# Officer Assessment Report

PA2403139

343 Royal Parade, Parkville

Officer Assessment Report  
Development Approvals & Design

Figure 6 Proposed landscape concept plan

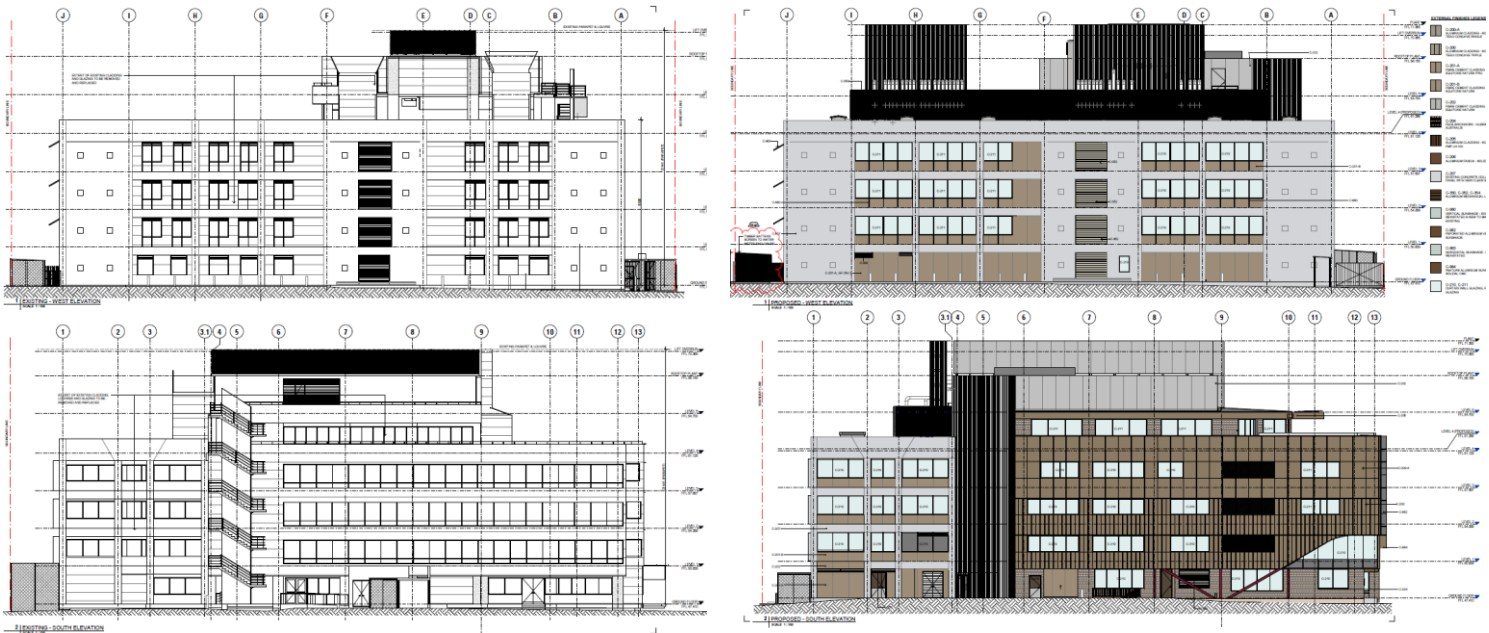
- Planter depths will need to meet minimum soil volume requirements especially for tree species. Were possible, ensure trees are planted into deep soil to ensure root systems have enough room to establish. If planting in planters ensuring interconnected soil volumes will help with root development and establishment.

- Level 4 planters would be better suited to the boundaries of the terrace to ensure minimum light levels and natural irrigation are met for the indicated species. If wanting to retain planters under canopy, species that can tolerate lower light levels will need to be considered.

- Irrigation, preferably drip, will need to be installed in raised garden beds and planters.
- Ensure all planters and raised garden beds have annotated drawings and include, drainage layer, root barriers, protection mats, substrate filters and water proofing details.

A permit condition is recommended to require amendments to the landscape plan to update planter depths, planters relocated to the terrace boundaries, drip irrigation, details of drainage layer, maintenance schedule and green factor tool.

- b) Level 4 planters on Building 5 relocated to the boundaries of the terrace to ensure minimum light levels and natural irrigation are met for the indicated species, or alternatively consider species suited to lower light levels if planters are retained under the canopy.
